AKD/KT
14487
17 June 2016

**SECTION 96(1A) - MODIFICATION APPLICATION TO SSD 6840
ST VINCENT'S PRIVATE HOSPITAL SYDNEY - REVISED STATEMENT OF ENVIRONMENTAL
EFFECTS**

Figure 2 – Approved design (above) and proposed split level (below)

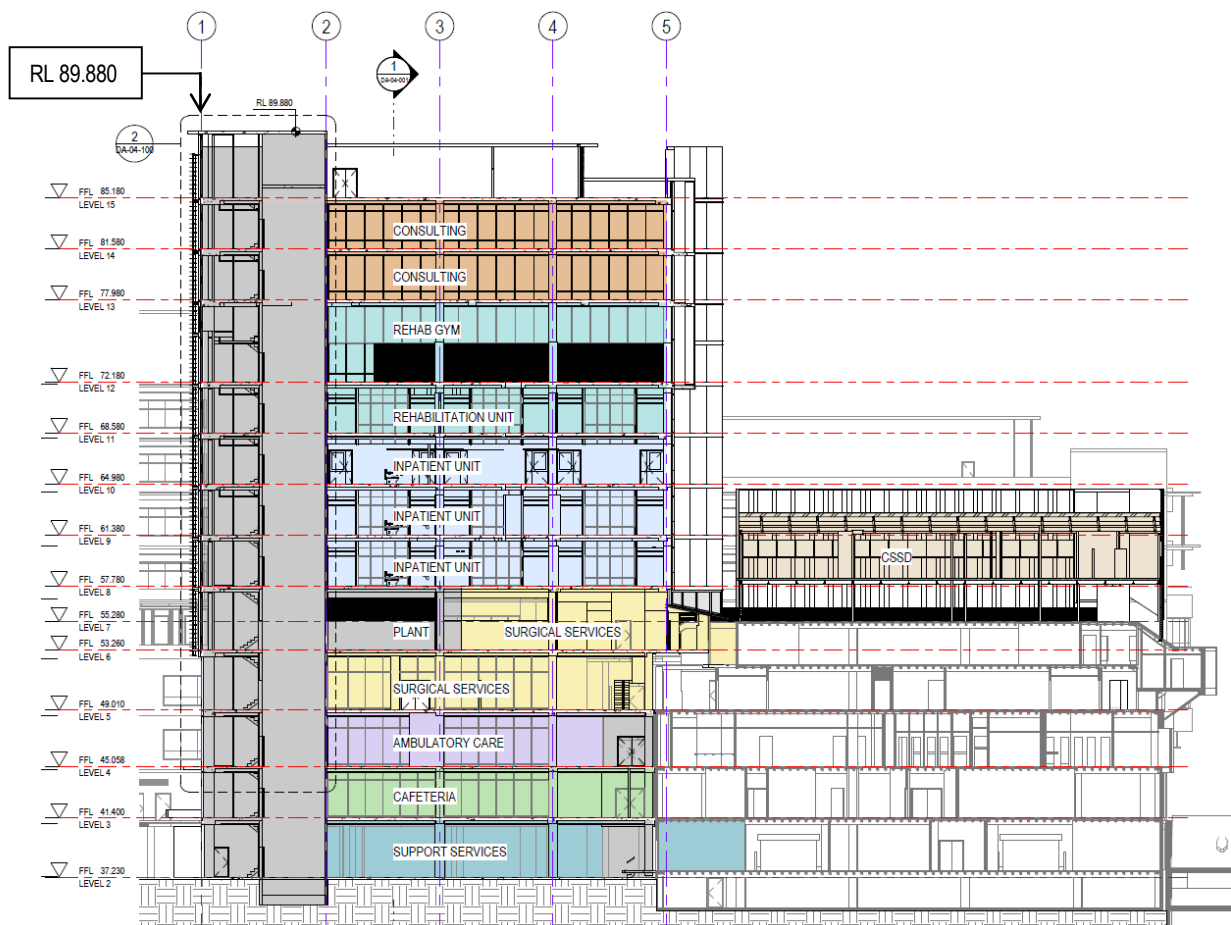
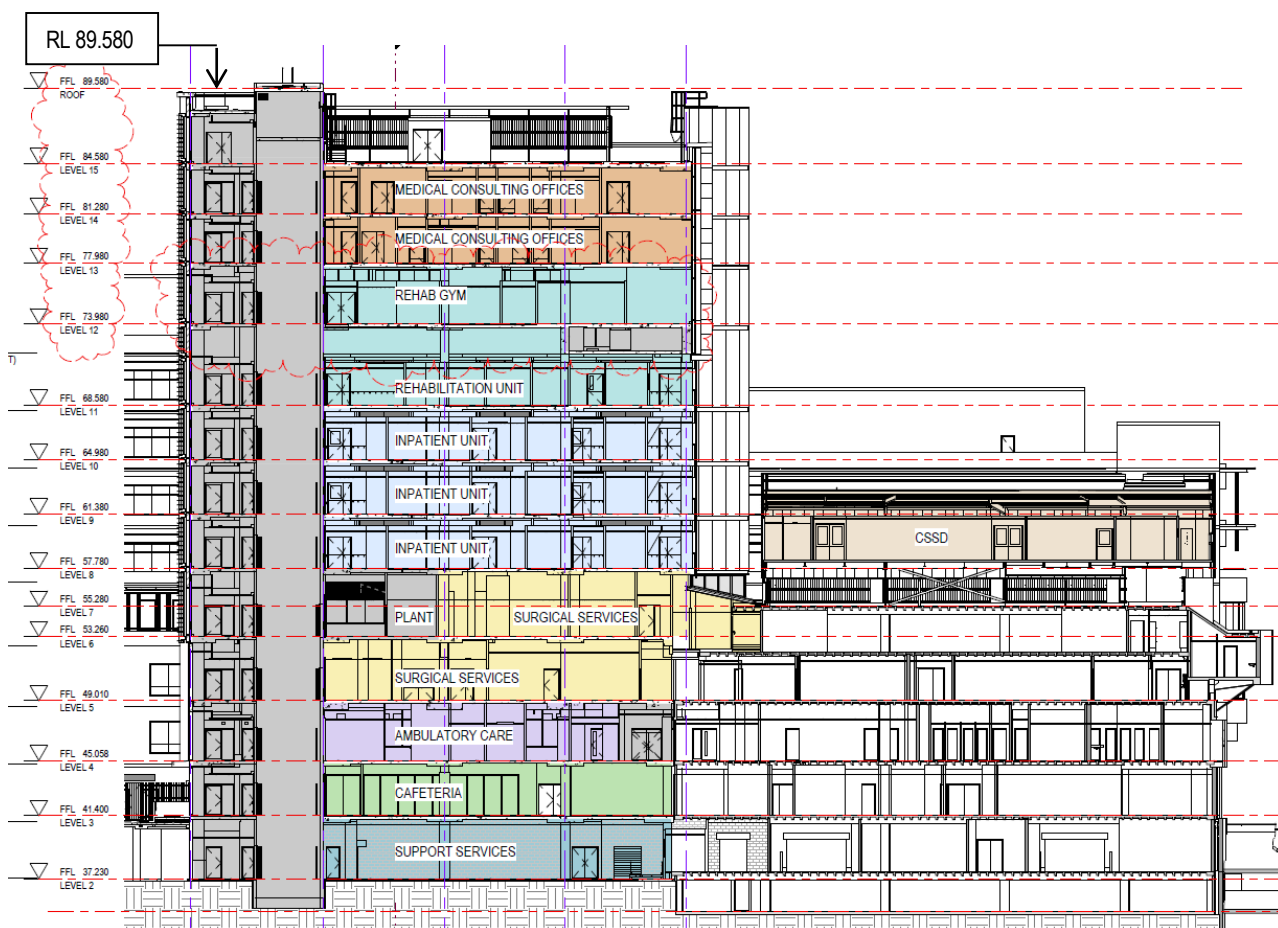
Amendments to the floor to floor heights are required to accommodate the aforementioned split level on Level 12 and the previously approved hydrotherapy pool. Whilst increases to the floor to floor heights are proposed on Level 12, those on Levels 14 and 15 have been reduced to maintain consistency with the building's approved height. The proposed changes are illustrated below in **Figure 2** and are detailed in **Table 2**.

Further, a slight amendment is proposed to the building height where the lift overrun is located on the north eastern section of the East Wing building. The amendment results in a decrease in the building height from 48.48m (RL 89.880) to 48.18m (RL 89.580), resulting in a 300mm reduction in height.

Level	Use	Approved (RL)	Proposed (RL)	Change (m)
Level 12	Plant / Rehab Gym / Hydrotherapy Pool	72.180	73.980	+1.8
Level 13	Consulting Suites	77.980	77.980	0
Level 14	Consulting Suites	81.580	81.280	-0.3
Level 15	Plant / Lobby / Meeting Room	85.180	84.58	-0.6
